MODEL 853 SCHEMATIC DIAGRAM

This supplement covers production changes, supplementary replacement parts list and partial Model 853 schematic. For all other information, refer to the 852, 853 and 854 service manual, Motorola Part No. 68P560322.

## PRODUCTION CHANGES (853 ONLY)

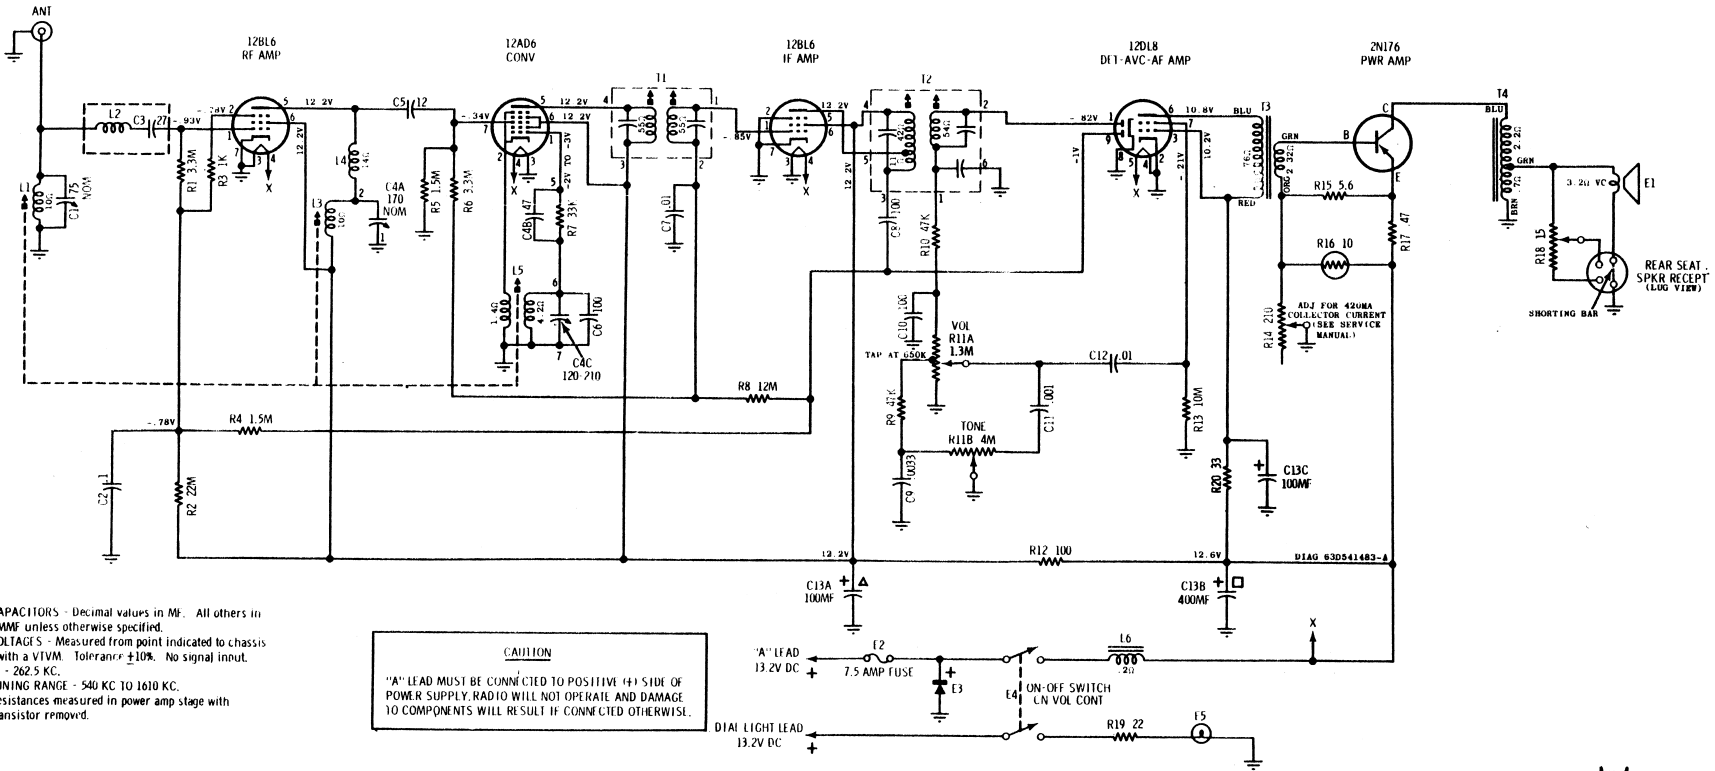
TO REDUCE MOTOR NOISE (See partial schematic)

R-12 (100 ohms) is changed to 390 ohms.

R-17 (.47 ohms) required.

R-21 (270 ohms) added in 12DL8 accelerating grid circuit.

C-13 Electrolytic capacitor increased in value from 100-100-400MF/16V (Part No. 23B542329) to 100-100-500MF/16V (Part No. 23B560487). (See supplementary replacement parts list.)

C-14 (.1 mf) added across selenium plate (E3) in input "A" lead circuit.

L-6 changed from two lead choke (Part No. 25K560752) to three lead tapped choke (Part No. 25C561000). (See supplementary replacement parts list)
